No. CF-96-06

AIRWORTHINESS DIRECTIVE

CF-96-06 BELL

Applies to Canadian registered Bell Helicopter Textron Inc. (Bell) Model 204B, 205A-1 and 212 helicopters equipped with emergency escape panels located in cargo doors of the main cabin.

Figure 1. Approximate Installation of Arrows

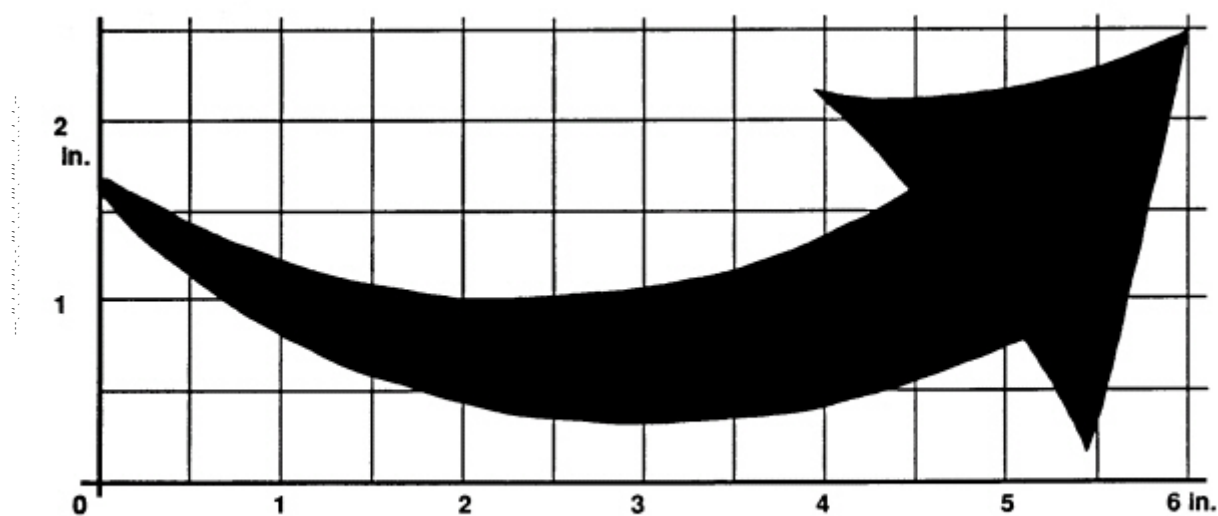
1. Install two conspicuous red arrows on each main cabin emergency escape panel as per the accompanying Figure 1. The shape and size of the arrows is specified in Figure 2. The arrows may be bright chrome yellow if the background colour is such that red would be inconspicuous.

Note: Installation of the arrows can be achieved by painting, application of decals or other means convenient to the operator. The required arrow is reproduced actual size in Figure 2 to facilitate fabrication of a stencil or decal.
